STOCKTON UNIFIED SCHOOL DISTRICT

Expanded Learning Opportunities Program (ELOP) - Relocatable Classroom Buildings

The following additions, deletions and revisions to the plans, specifications and Addenda shall become a part of the plans and specifications. It is the responsibility of the General Contractor to submit the information contained in this addendum to all subcontractors and suppliers. The Bidder shall acknowledge receipt of the Addendum in the Bid Proposal. (Addendum number of pages: **32** pages + **77** attachments = **109** total pages).

JOB NUMBER:
23-12909
DWG. DATE:
02/20/25
AD1-RIO-
A201

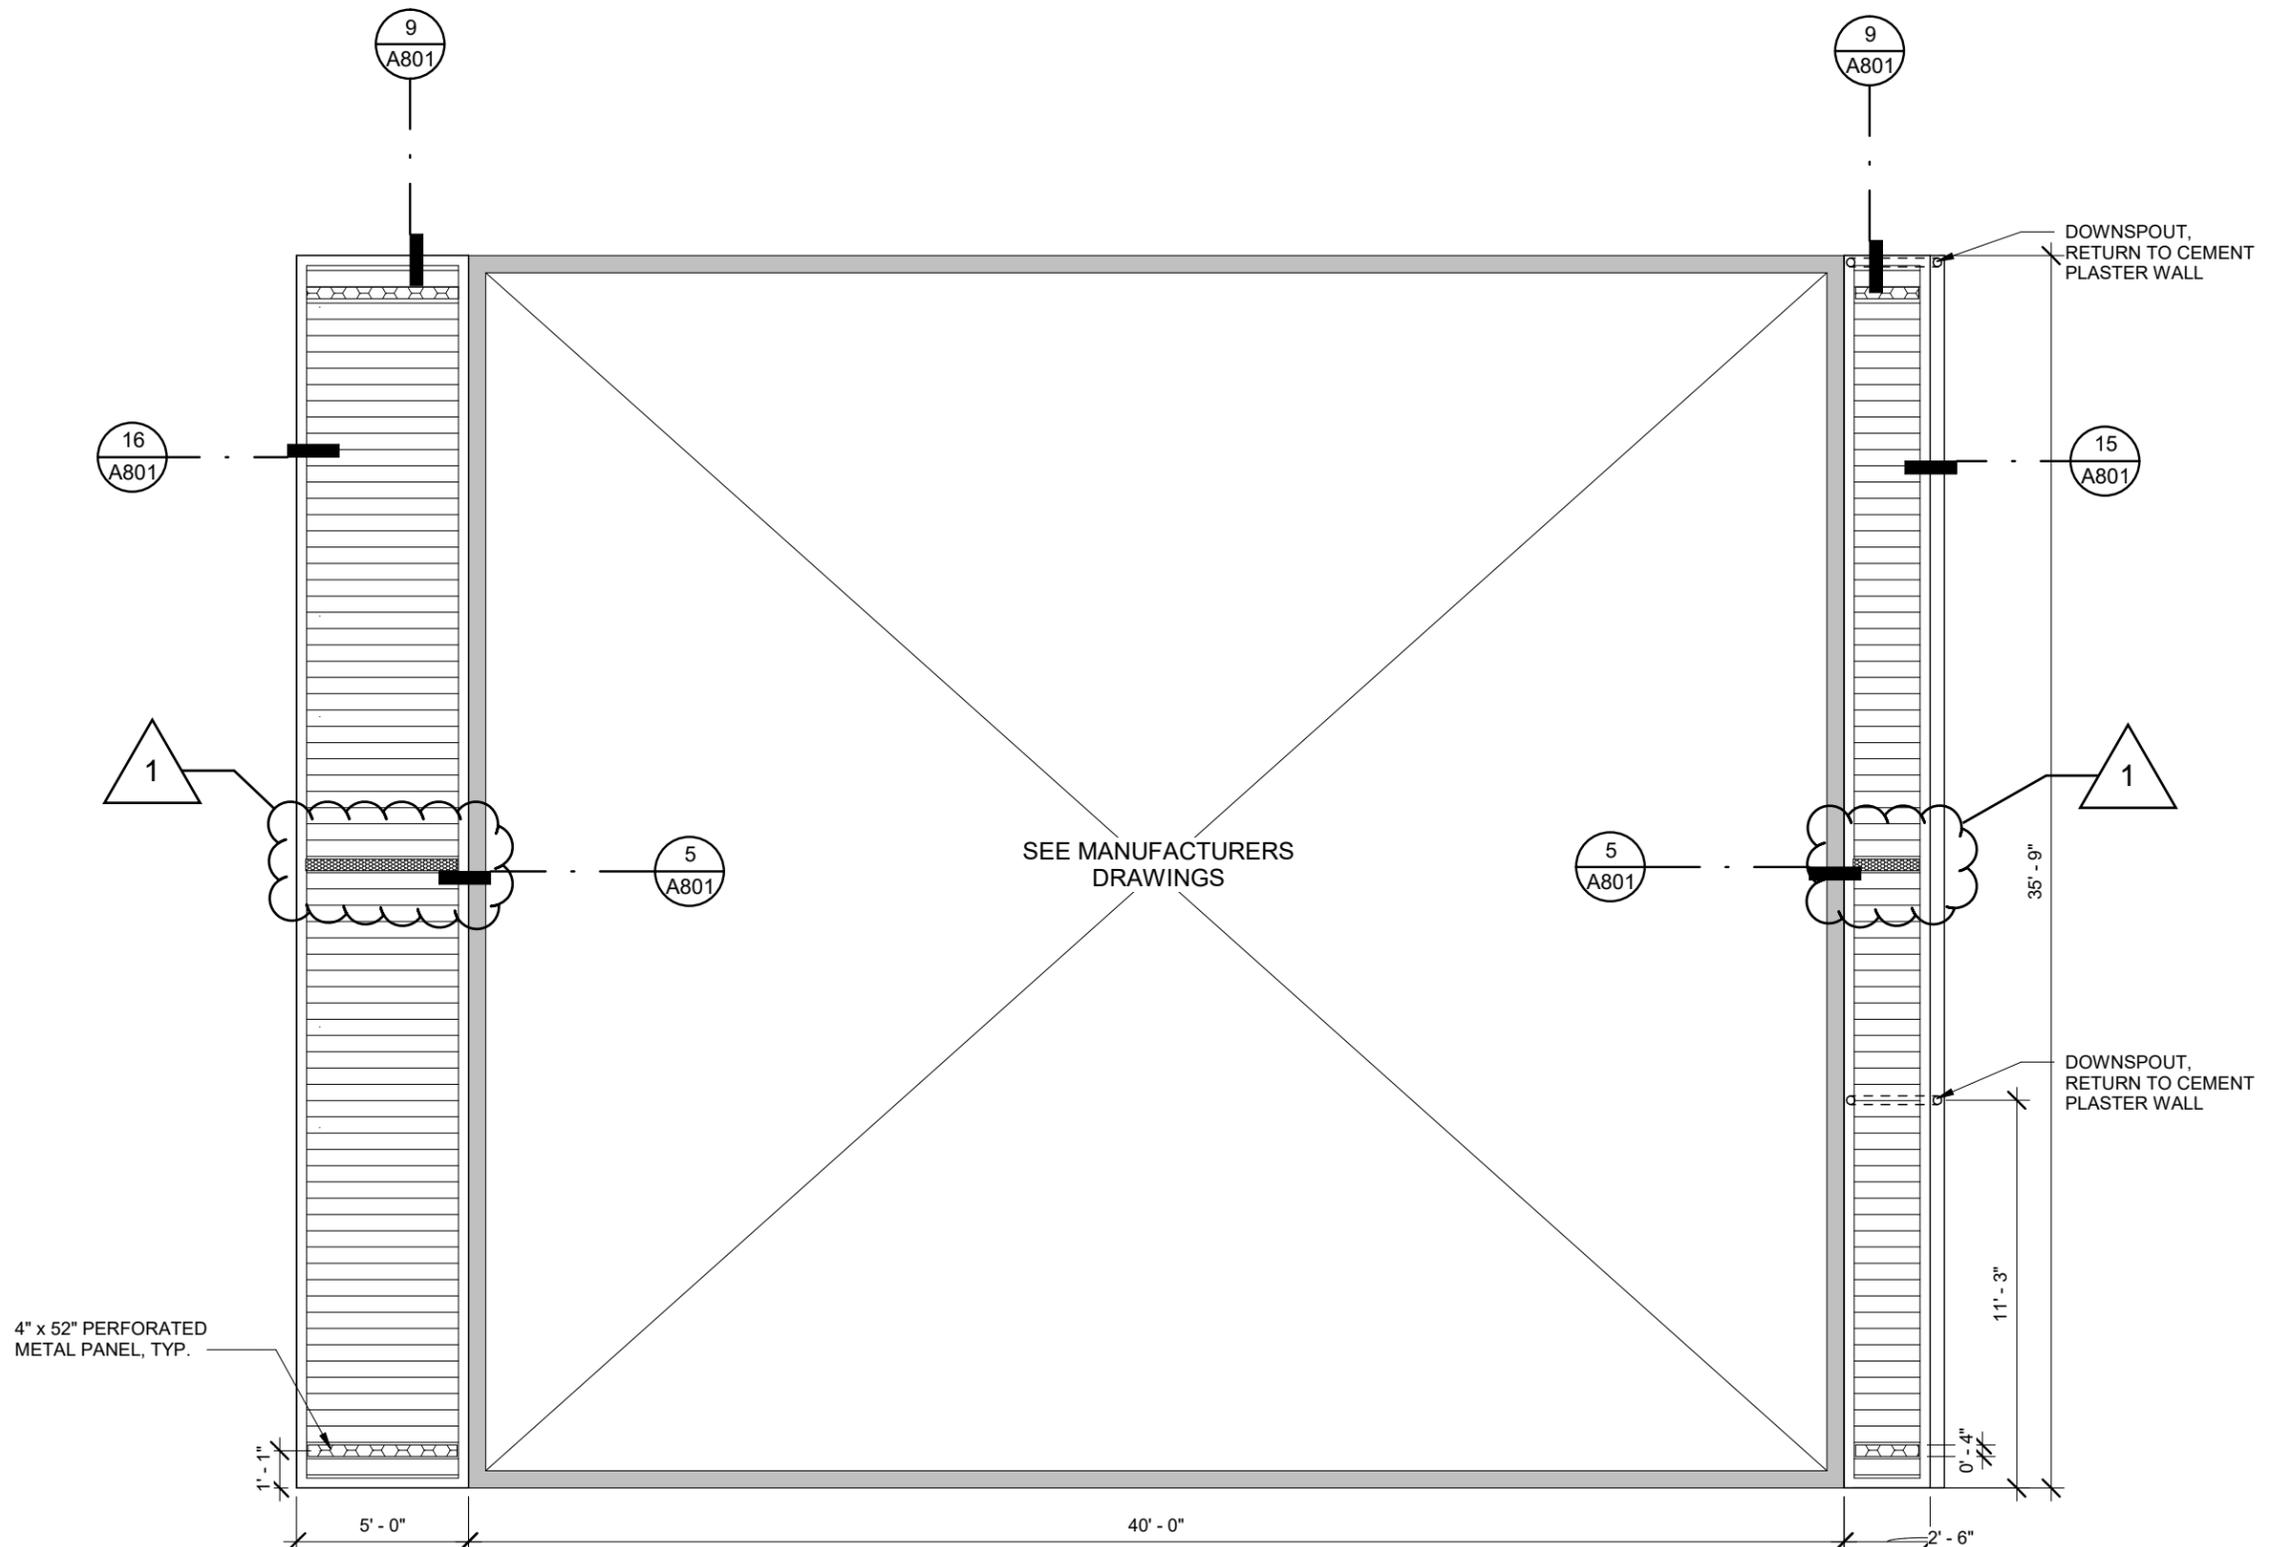
1 - 082: DRAWINGS, SHEET A201 – “PLUMBING FLOOR PLAN”, revise as follows:

A. Per attached drawing **AD1-RIO-A201**.

1. Detail 1 has been revised.
